Addendum to IFB

IFB NUMBER: IFB 23-035/JW
IFB TITLE: Crane Bayou Pump Station Generators and Building – Community Development Block Grant-Disaster Recovery (CDBG-DR) Program Project for Jefferson County
IFB DUE BY: 11:00 AM, CT, WEDNESDAY, JUNE 21, 2023
ADDENDUM NO.: 3
ISSUED (DATE): June 16, 2023

Reason for Issuance of this Addendum: CLARIFICATIONS, PAGE REPLACEMENT, WAGE RATES, AND GEOTECHNICAL REPORT

Crane Bayou Pump Station Generators and Building – Community Development Block Grant – Disaster Recovery (CDBG-DR) Program Project for Jefferson County

C-2

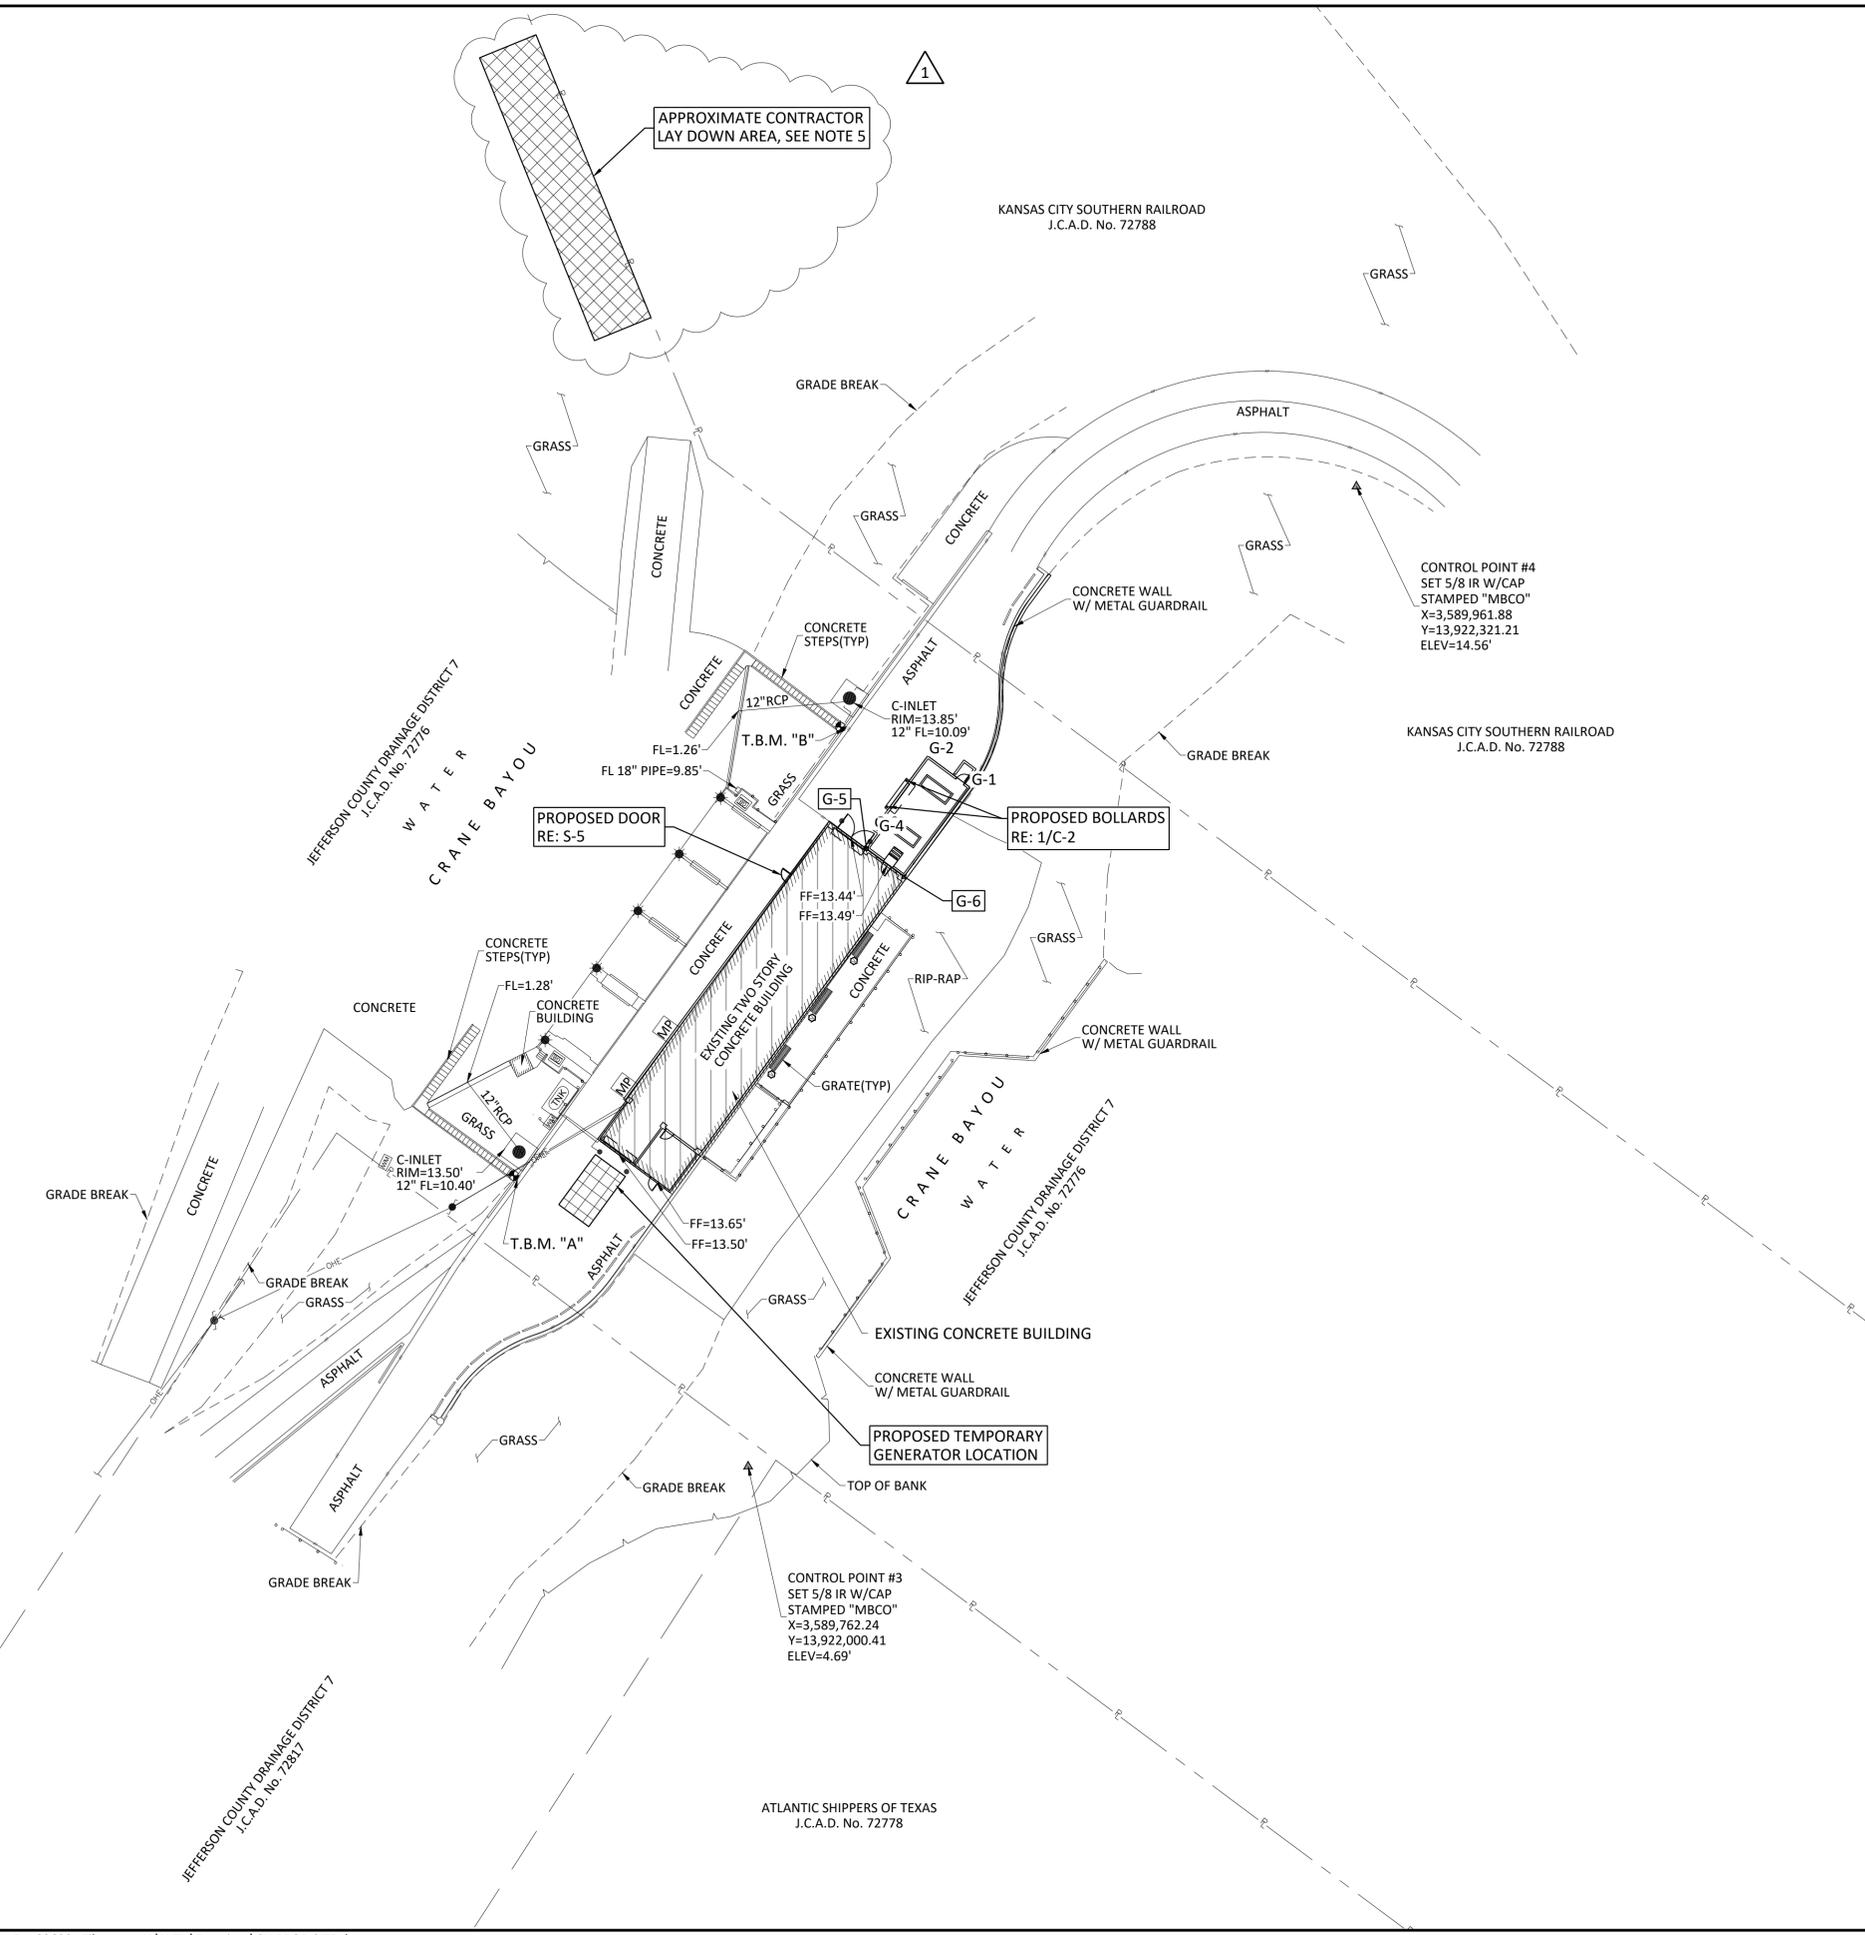
Question: On sheet C-2 it states we cannot park a vehicle larger than a 3/4" ton vehicle on the level or within the toe. Can you clarify the intent of this note as this will impact construction? Will we be able to bring concrete trucks on the levee? What about setting up a crane to set the generators and concrete roof panels? We will likely need large equipment within the toe for the majority of the project.

Replace sheet C-2 with the attached sheet C-2.

Answer: The intent of this requirement is to mat heavy loads. Specifically, heavy loads such as concrete trucks or tractor/trailers crossing the pump station intake will need to be matted. Cranes will also need to be matted.

- CONTRACTOR SHALL NOT PARK ANY VEHICLE LARGER THAN A 3/4 TON TRUCK ON TOP OF THE LEVEE OR WITHIN THE TOE (INDICATED BY A GRADE BREAK ON THIS SHEET) WITHOUT WRITTEN APPROVAL FROM THE OWNER.
- EQUIPMENT AND VEHICLES LARGER THAN A 3/4 TON TRUCK MAY STAGE ON THE LEVEE FOR THE PURPOSES OF LOADING AND UNLOADING ONLY.
- CONTRACTOR IS CAUTIONED THAT THE OWNER WILL BE OPERATING THE PUMP STATION THROUGHOUT CONSTRUCTION AND SHALL KEEP ROADWAYS AND ACCESS POINTS CLEAR TO ALLOW FREE MOVEMENT FOR OWNER'S OPERATIONS AND MAINTENANCE STAFF.
- TEMPORARY GENERATOR SHALL BE TRAILER MOUNTED. CONTRACTOR SHALL COORDINATE WITH OWNER IF GENERATOR NEEDS TO BE TEMPORARILY RELOCATED TO ALLOW ACCESS TO THE SOUTHWEST ROLL UP DOOR.
- CONTRACTOR MAY USE JEFFERSON COUNTY DD7 PROPERTY FOR LAYDOWN AREA ABOVE ELEVATION 8 FEET.
